Urgent Field Safety Notice Afinion™ CRP system

FSCA-identifier: MP12/1086

Warning about possible misinterpretation of an information code as a CRP test result and reduced opened vial stability of Afinion™ CRP Control.

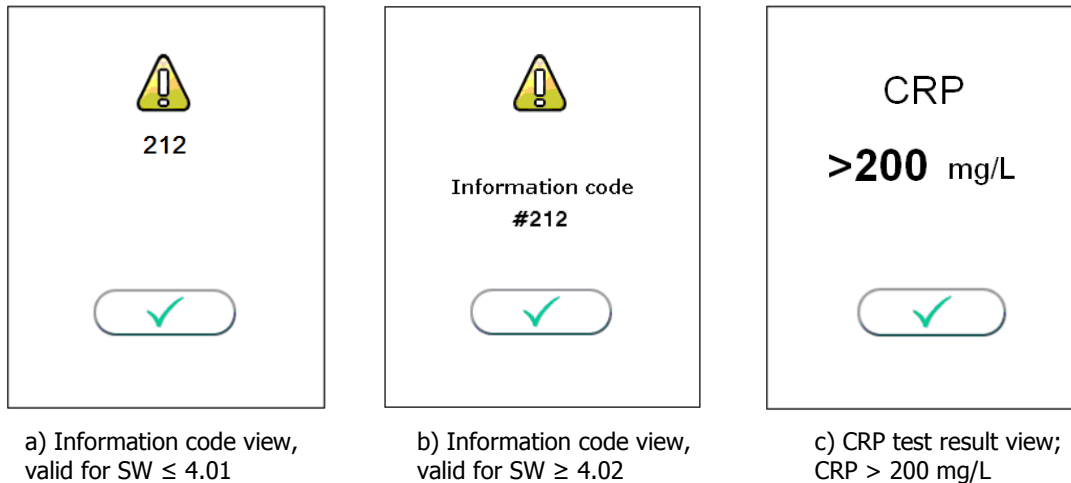
To significantly reduce the risk of misinterpreting an information code as an assay result a change in the information code view has been implemented, valid from SW 4.02. The message "Information code" appears in the selected language along with a hash sign (#) and the code number.

Please see the illustration below of the information code view valid for $SW \leq 4.01$ and of the improved information code view valid for $SW \geq 4.02$. In contrast a CRP result > 200 mg/L is illustrated.

- 1) Please read the instructions in the Afinion™ AS100 Analyzer User Manual and in the Afinion™ CRP Package Insert to revise how to correctly interpret an information code versus a CRP result.
- 2) The more intuitive information code view, implemented from SW 4.02, will significantly decrease the likelihood of misinterpretation. The Afinion™ Analyzer SW 4.02 is launched by the manufacturer, and the upgrading of the instruments is in progress. You will be contacted by your supplier, if you have not already been contacted, regarding upgrading of your Afinion™ AS100 Analyzer.
